Vettura: *FERRARI 365 GT4/BB*

Oggetto: *MODIFICA CARBURATORI WEBER 40 IF 3C/1-2-3-4*

SAT
CIRCOLARE TECNICA
TECHNICAL INFORMATION

Nº *252*

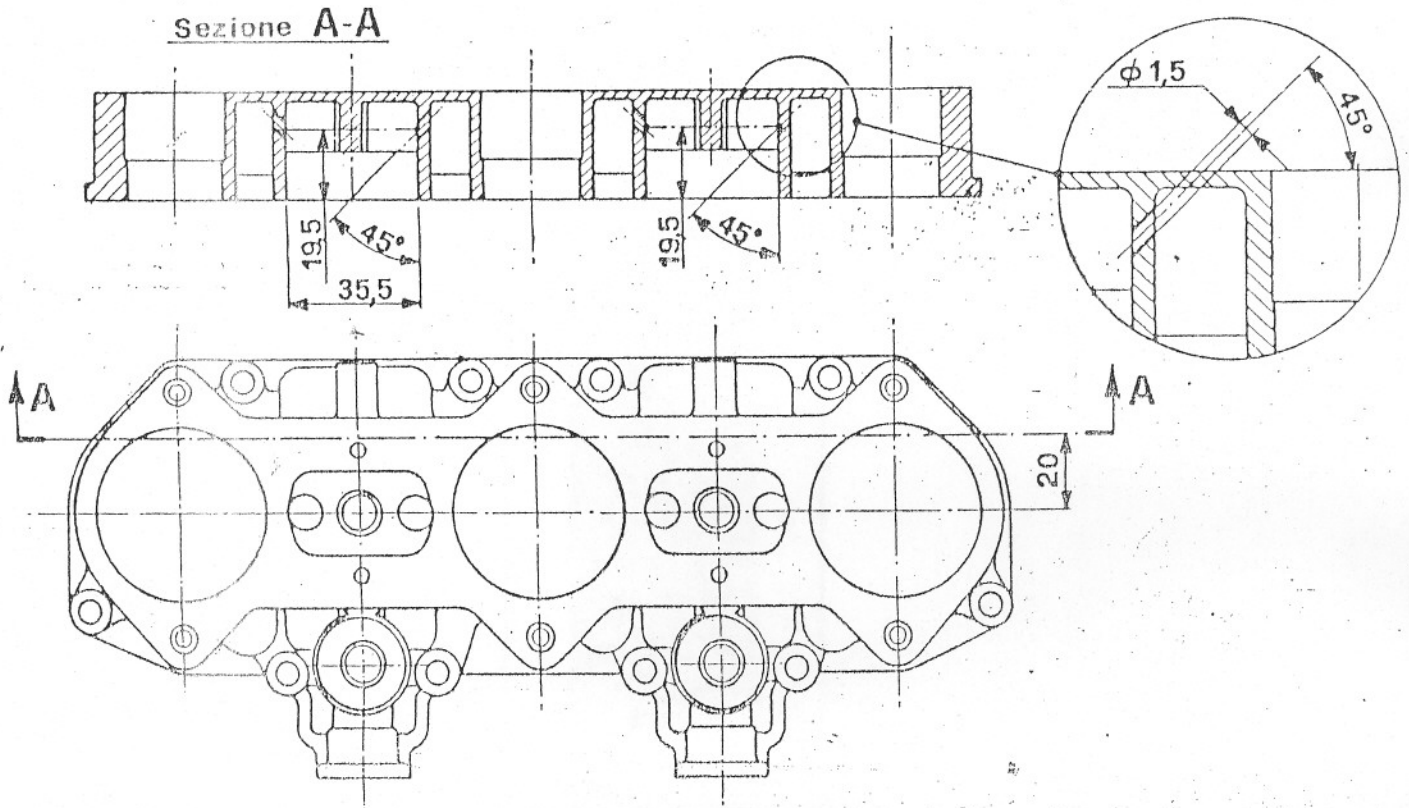
*Sul coperchio di ciascun carburatore occorre praticare N°4 fori di sfiato di $\phi 1,5$ come indicato in figura.
Eseguita la modifica Vi preghiamo di contrassegnare ciascun carburatore con un bollo di vernice verde.*

On each carburettor cover you will need to drill 4 each, 1.5mm diameter holes as shown in the above figure
After the modification, please mark the carburettor with a green spot. FERRARI ASSISTENZA TECNICA

*On each carburettor cover it is necessary to drill N°4 breather holes as shown in the enclosed drawing.
After the modification we kindly ask you to mark each carburettor with a green painted spot.*
